Date: Sun, 05 Oct 2003 17:29:20 +0000
To: ve7bqh@shaw.ca, kl6m@arrl.net
From: Peter Sundberg <sm2cew@telia.com>
Subject: 2 mtr quad

2m quad feed dimensions:

Subject: Re: 144 quad feed

Electrical data

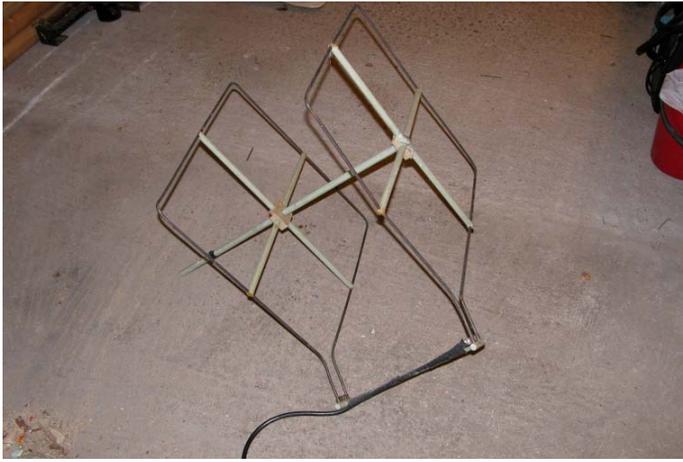
<u>Fq</u>	<u>R</u>	<u>X</u>	<u>Returnloss</u>
143.800	59	0	
144.000	56	0	24 db
144.200	53	0	
144.400	51	1	38 db
144.600	49	3	31 db
144.800	47	5	25 db
145.000	45	7

Bandwidth vswr 1.5:1 from 142.6 -> 146.5, wider than I thought!
